# Groundwater Transfer Review Summary Form

Transfer/PA # T- 14754

Application: T-14754

Applicant Name: Mariah and John DeRosier

Map

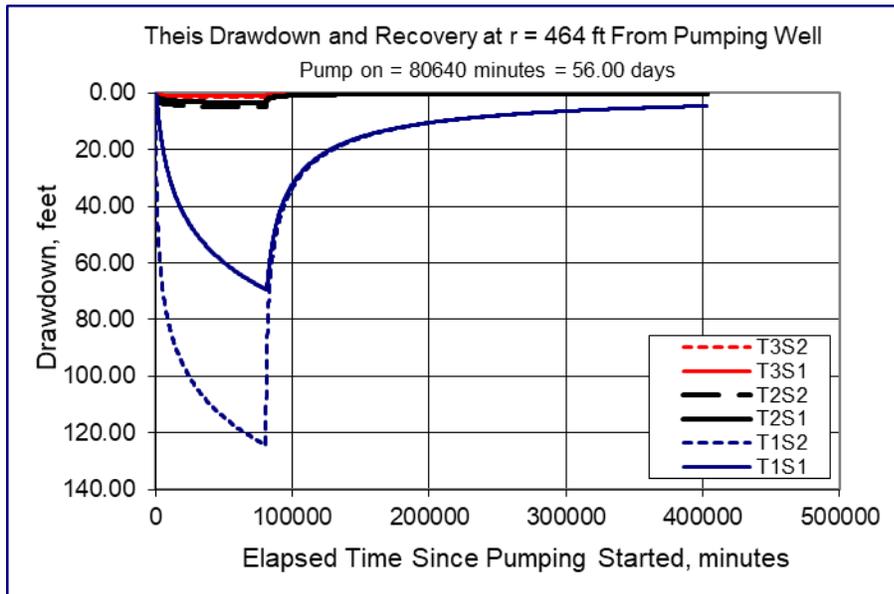
5. a) Will this proposed change, at its maximum allowed rate of use, likely result in an increase in interference with **another ground water right**?  
 Yes    No   Comments: The proposed APOA, POA 2/Well 2 (LANE 7726) is closer to LANE 7719 than the authorized POA, POA 1/Well 1 (LANE 7738). The reduced intervening distance is likely to increase interference with LANE 7719.

- b) If yes, would this proposed change, at its maximum allowed rate of use, likely result in another groundwater right not receiving the water to which it is legally entitled?  
 Yes    No   If yes, explain: The APOA, POA 2/Well 2 (LANE 7726) is approximately 464 ft north of LANE 7719. The Theis (1935) solution for drawdown in a confined aquifer was used to assess the potential for injury to LANE 7719 from the proposed changes (see attached Theis Interference and Injury Analysis). Results indicate the proposed change is unlikely to result in LANE 7719 not receiving the water to which it is legally entitled.
